APPLICATION NO.	FILING DATE	FIRST NAMED INVENTOR	ATTORNEY DOCKET NO.	CONFIRMATION NO.
10/790,917	03/02/2004	Martin B. Cantrell		1396

Office Action Summary	Application No. 10/790,917	Applicant(s) CANTRELL, MARTIN B.	
	Examiner Paul Devoti	Art Unit 3637

DETAILED ACTION

Lew (US 4652170) Figures 21 and 22

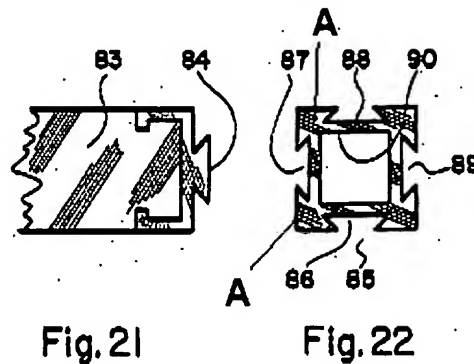
16. Regarding claim 3, the mortise and tenon joint is a dovetail joint (as seen in Figures 21, 22).

17. Regarding claim 4, the second member (84) is non-planar, as it has angled edges around the tenon.

18. Regarding claim 6, the first members (A) have one end which is angled and provides an ornamentation.

19. Regarding claim 7, the first members (A) have one end with a functional feature in the form of a screw or locking plug (column 6, lines 38-41).

20. Regarding claim 8, the panel (83) has channels that receive the second member (84).

21. Regarding claim 9, the first member (A) contains a conduit along its edge which receives the second member (84).

22. Regarding claim 10, the second member (84) contains a conduit which receives the panel (83).

23. Regarding claims 11-12, two separate first members (A) form a mortise (87) configured to receive a tenon (84). The mortise (87) is a female dovetail slot and the tenon (84) is a male dovetail.
